## HISTORIC AND DESIGN REVIEW COMMISSION

Agenda Item No: 22

**HDRC CASE NO:** 2016-095  
**ADDRESS:** 415 MARY LOUISE  
**LEGAL DESCRIPTION:** NCB 6703 BLK 13 LOT 3  
**ZONING:** R6 H  
**CITY COUNCIL DIST.:** 7  
**DISTRICT:** Monticello Park Historic District  
**APPLICANT:** David Whitworth  
**OWNER:** David Whitworth  
**TYPE OF WORK:** Carport  
**REQUEST:**

The applicant is requesting a Certificate of Appropriateness for approval to increase the footprint and height of an existing non-historic carport. The new carport will be 22'x25' with a 15' ridge height.

415 MARY LOUISE  
SITE PLAN

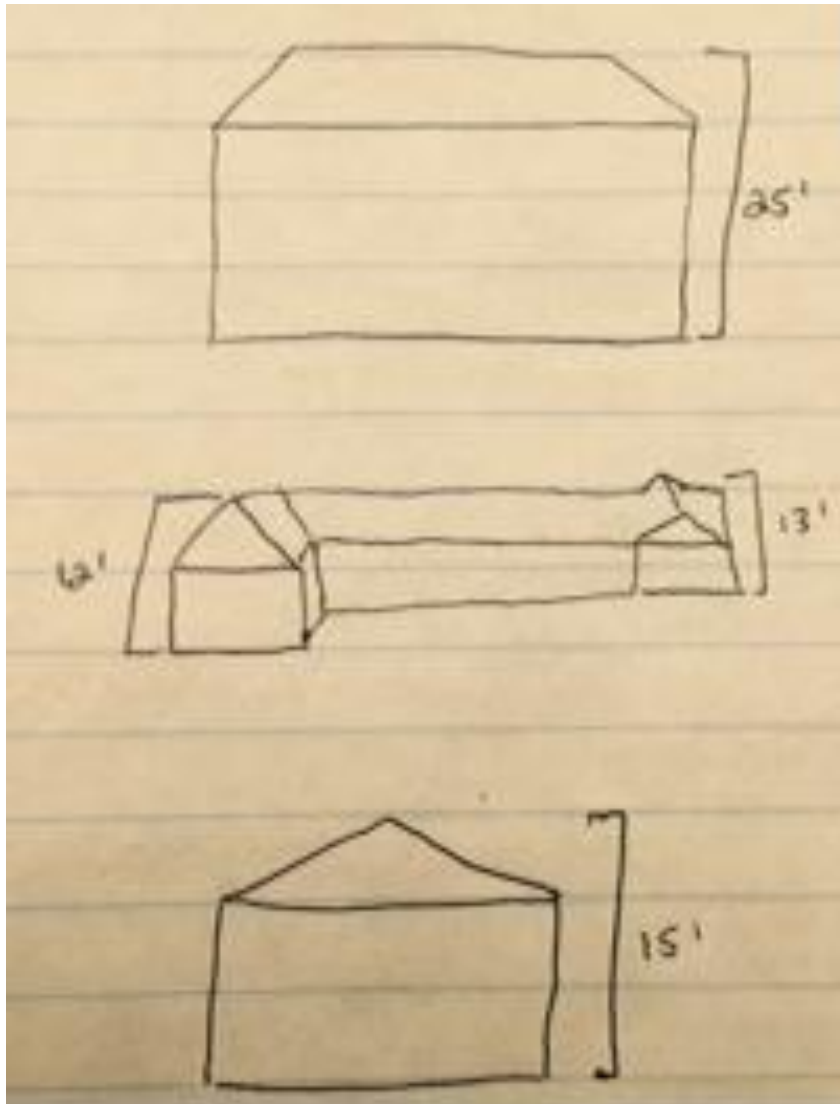
- g. The applicant is proposing to build a new carport that is not attached to the garage. The new carport is 22' x 25', 550 square feet, has a front gable roof with a 15' ridge height and a 10' clearance to accommodate a new vehicle. The side setback remains at 5 feet. According to the Guidelines for New Construction 5.A., new outbuildings should be no larger in plan than 40% of the principal historic structure's foot print, and should be visibly subordinate to historic structures. In regards to height and massing, staff finds the proposed carport 15' ridge height overwhelms the historic garage. This is inconsistent with the guidelines. Staff recommends that the applicant consider a flat roof which would be transparent from the public right-of-way and relate to the historic garage.

Staff does not recommend approval based on findings g.

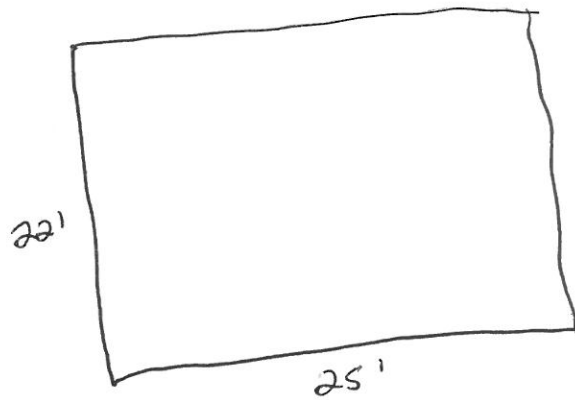
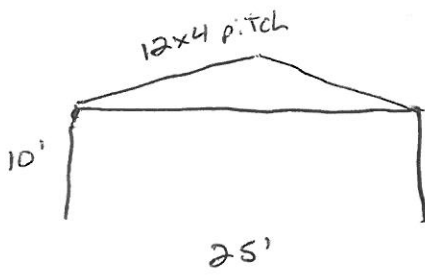
- d. The previous carport had a flat roof, and was 18' x 17' x 8' and located at the end of the existing driveway, with a 5' side setback.
- e. The applicant is proposing to rebuild the carport in the location of the previous carport with the same access. Staff made a site visit on March 5, 2016, and found that rear garages and carports along the block. This is consistent with the Guidelines for New Construction 5.B, which recommends new outbuildings match predominant garage and carport orientations.
